# Access Compliance Report

## Public Rights-of-Way

Intersection ID: 28018	Main Street: COLONIAL_COUNTRY_LN	Cross Street: CONGRESSIONAL_CLUB_DR	Location: SW
ADA ID: D8081E328AD6	Ramp Type: PerpDiag	Initial Pass/Fail: Fail	Overall Compliance: No
Codes/Mitigation Info/Possible Solution		Field Measurements/Component Compliance	
Severity Score: 8.75

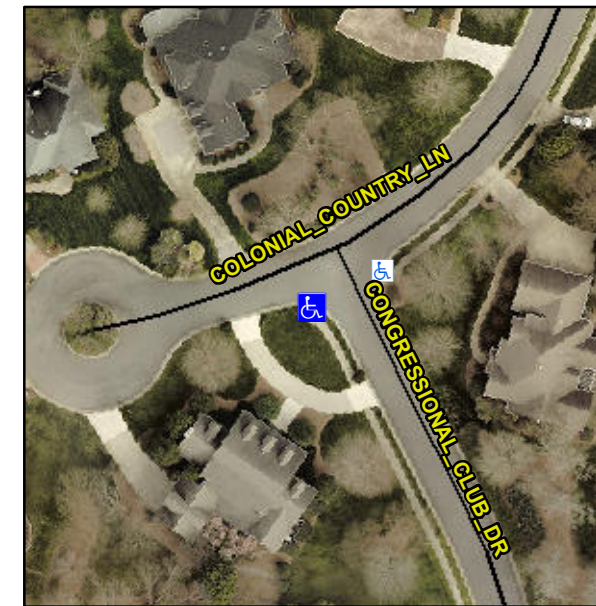
**Not Found, R304.5.1**

Compliance	Description	Data	Compliance	Description	Data
N/A	Ramp Length (in)	96.0	Yes	Ramp Slope (%)	5.1
No	Ramp Width (in)	47.0	Yes	Ramp XSlope (%)	1.5
N/A	Flare Type LT	N/A	N/A	Flare Type RT	N/A
N/A	Flare Slope LT (%)	N/A	N/A	Flare Slope RT (%)	N/A
N/A	Flare Traversable LT?	N/A	N/A	Flare Traversable RT?	N/A
N/A	Landing Length (in)	N/A	N/A	DWS Provided?	N/A
N/A	Landing Width (in)	N/A	N/A	DWS Contrast?	N/A
N/A	Landing Slope (%)	N/A	N/A	DWS Length (in)	N/A
N/A	Landing X Slope (%)	N/A	N/A	DWS Full Width?	N/A
N/A	Landing Curb? (Y/N)	N/A	N/A	DWS Offset (in)	N/A
N/A	Shared Landing?	N/A			
N/A	Gutter Ponding?	N/A	N/A	Gutter Slope (%)	N/A
N/A	Gutter Lip Ht (in)	N/A	N/A	Gutter X Slope (%)	N/A
N/A	Painted X Walk1?	No	N/A	Painted X Walk2?	No
	X Walk 1 Direction	To NE		X Walk 2 Direction	To N
N/A	X Walk 1 Width (in)	N/A	N/A	X Walk 2 Width (in)	N/A
	X Walk 1 Slope (%)	1.5		X Walk 2 Slope (%)	2.3
	X Walk 1 X Slope (%)	1.5		X Walk 2 X Slope (%)	1.7

**Remove & Replace Curb Ramp With Two New Directional Ramps or Equivalent.**
